Preliminary responses to OEH and SEWPaC comments on the Preferred Project
Report and Response to Submissions — biodiversity (26 March 2013)

Re: Cobbora Coal Project – Preliminary Responses to OEH and SEWPaC Comments on the Preferred Project Report and Response to Submissions – Biodiversity

DATE: 19/3/2013
MEMO TO: Department of Planning and Infrastructure – Stephen O’Donoghue
FROM: Gavin Heydon
SUBJECT: CLARIFICATION OF TAILINGS INFORMATION
REFERENCE:

The purpose of this addendum is to correct the results presented in Appendix E that were affected by a water balance model error, and to discuss the wider implications of the error for the Surface Water Assessment and Environmental Assessment. In addition, further information is provided in the addendum on additional model sensitivity analyses undertaken to address a concern of the DP&I's reviewer regarding the reliance of the mine on the surface water entitlement from the Cudgong river source. Specifically, the reviewer raised the concern that the volume of groundwater inflow to the mine pits available for use in the mine water management system may have been overestimated.

Figure B.1 – Simulated daily storages for all dam types for mine stage year 1

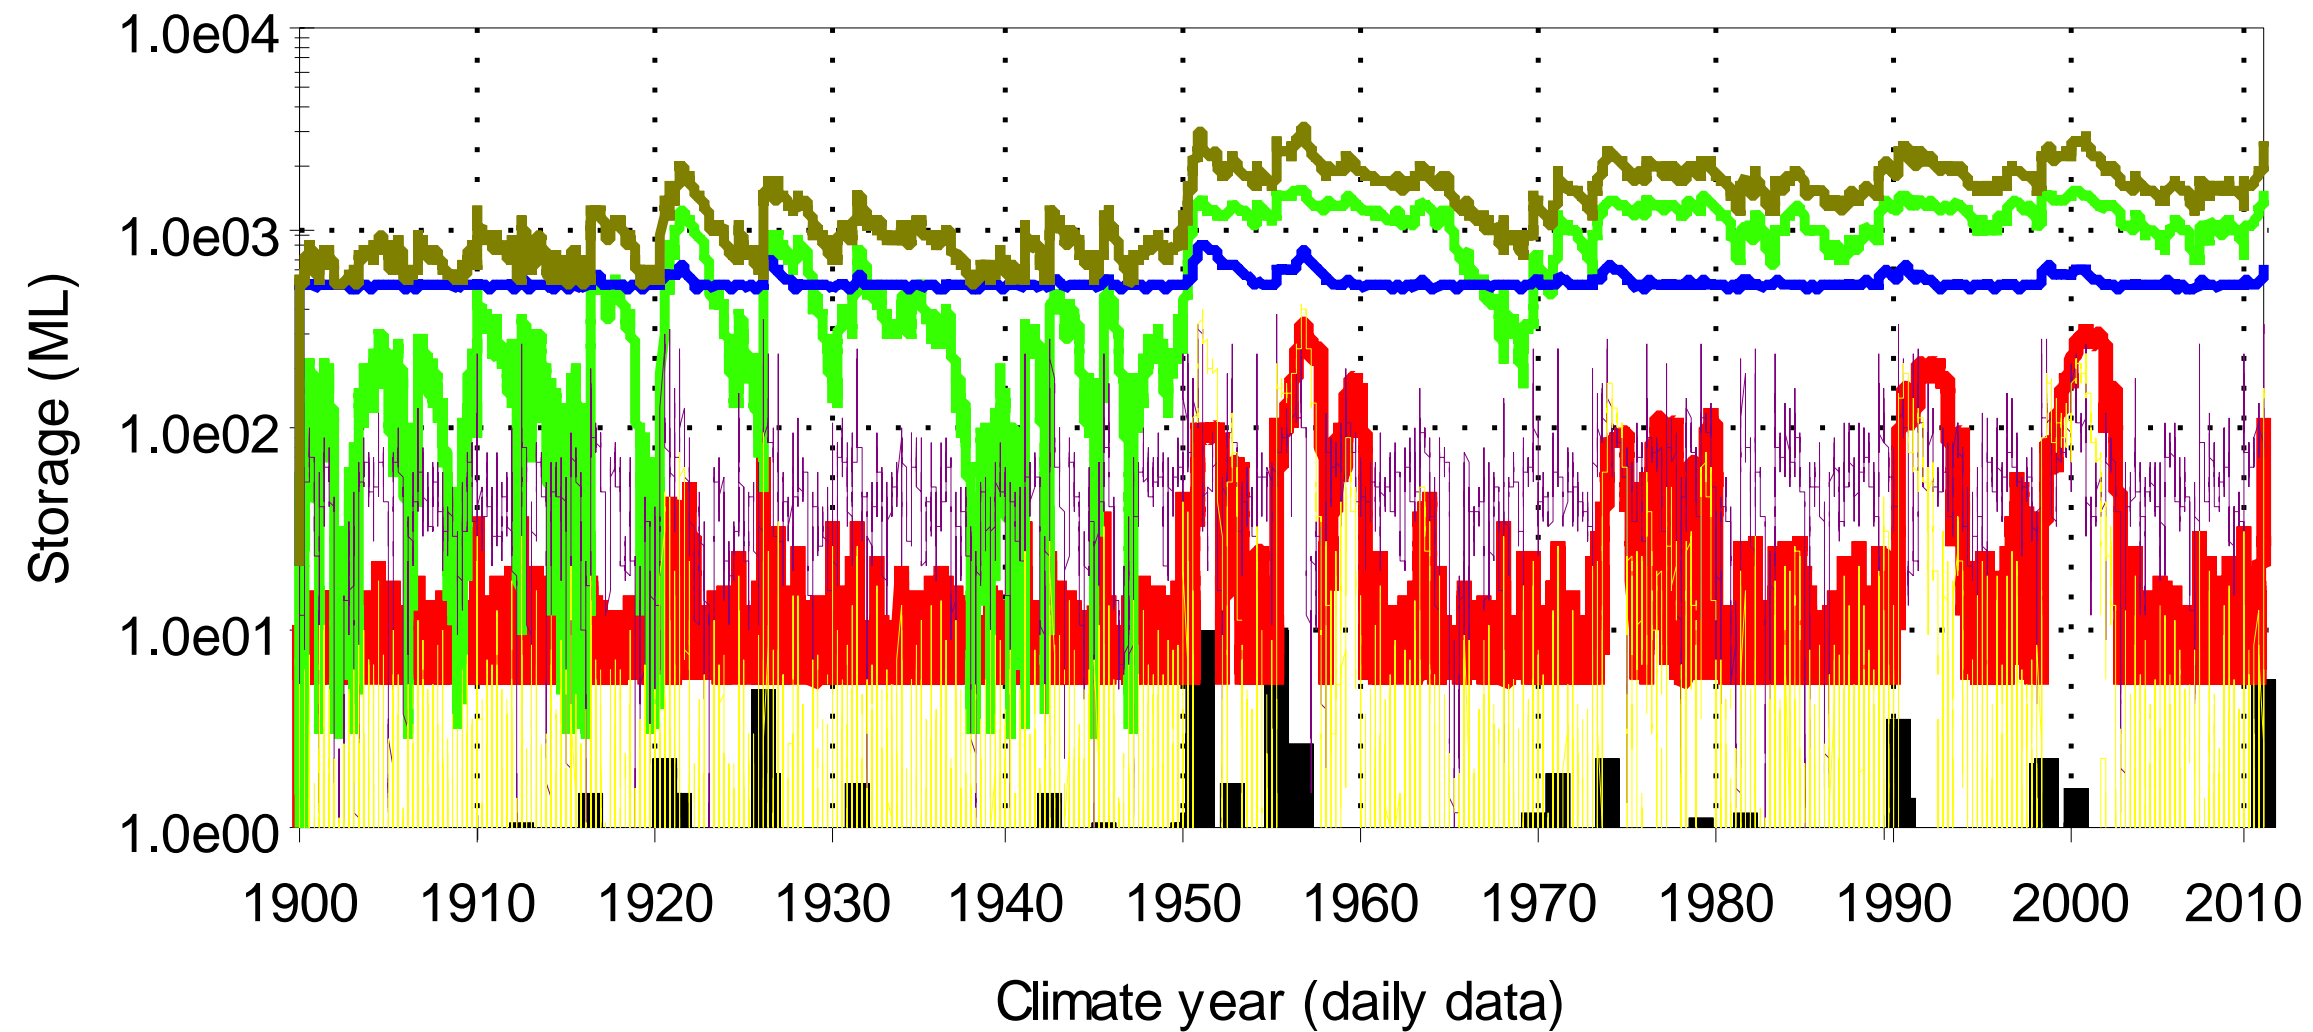
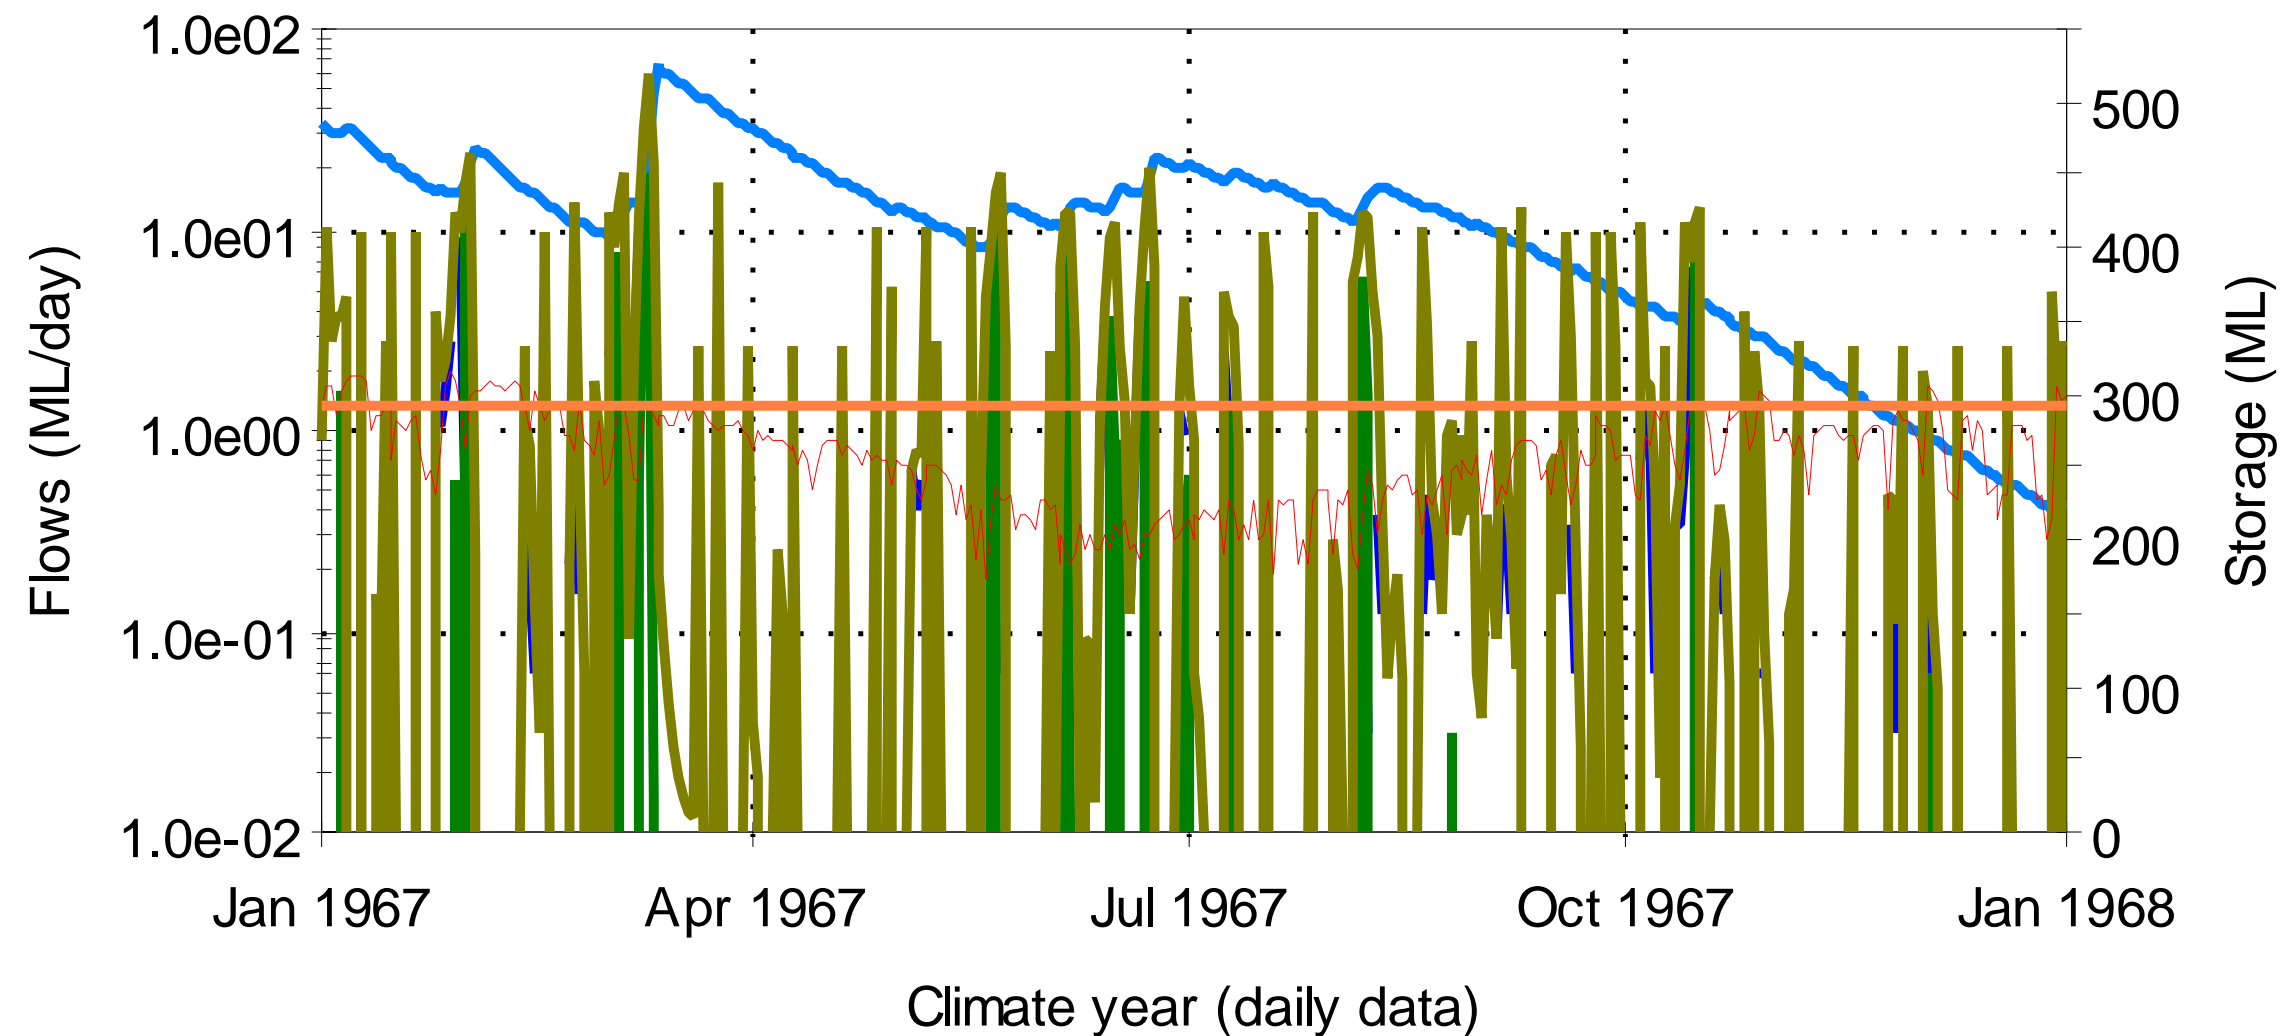
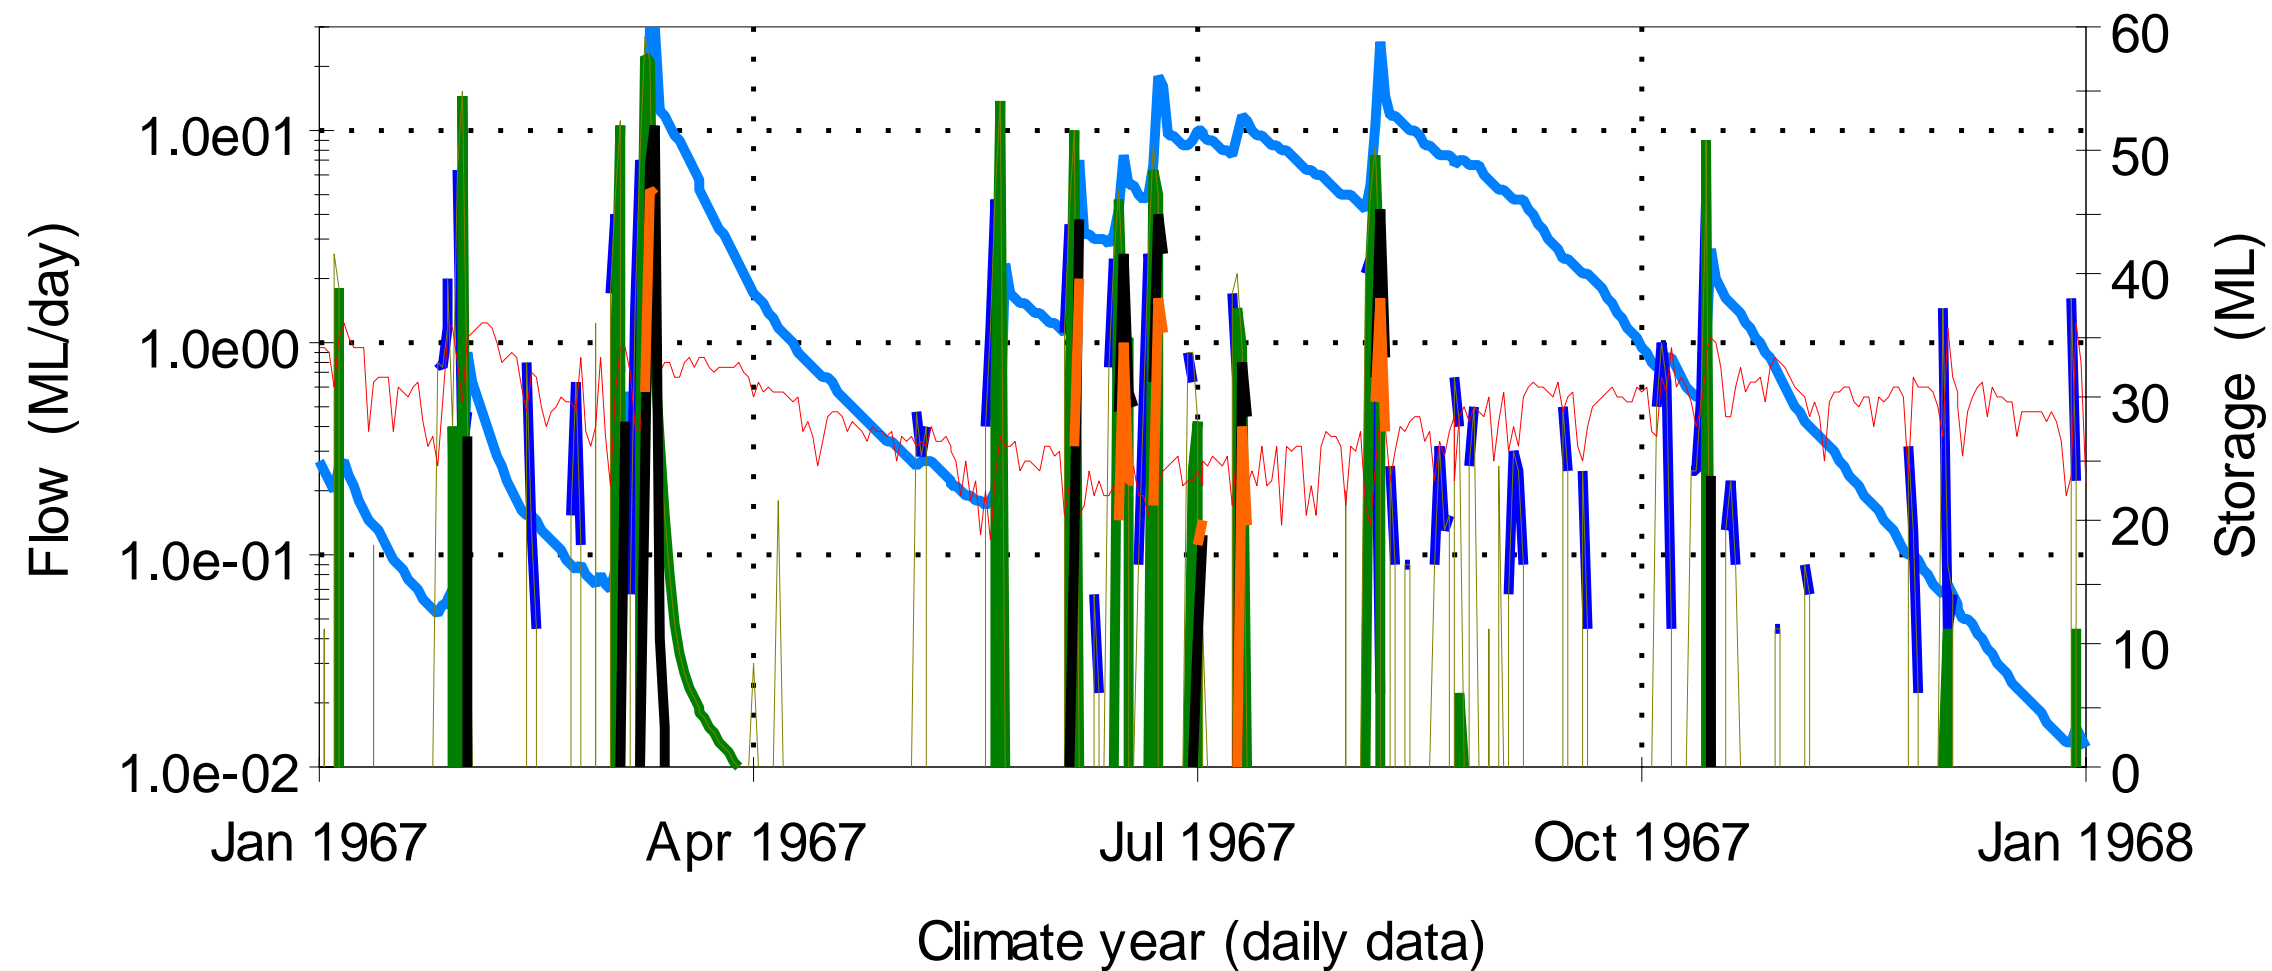
Additional figures are presented in Appendix B to demonstrate the water balance for the different types of dams in the GoldSim model. The figures are based on Year 1 of operation and demonstrate that the project dams build up storage in the system within a year of operation. Figure B.1 provides an overview of the water balance in all dam types for the entire simulation. Figures B.2 to B.6 provide water balance results for the mine water dams, sedimentation dams, pits, the raw water dam and tailings dams for mine stage year 1 and the 10th percentile rainfall (dry) year of 1967. While not all time series results are easily visible on the charts, the main purpose of the figures is to demonstrate the variation in storage within the different dam types throughout the 10th percentile (dry) year, and the initial and final storages at the start and end of the year. More detailed results can be provided if required.
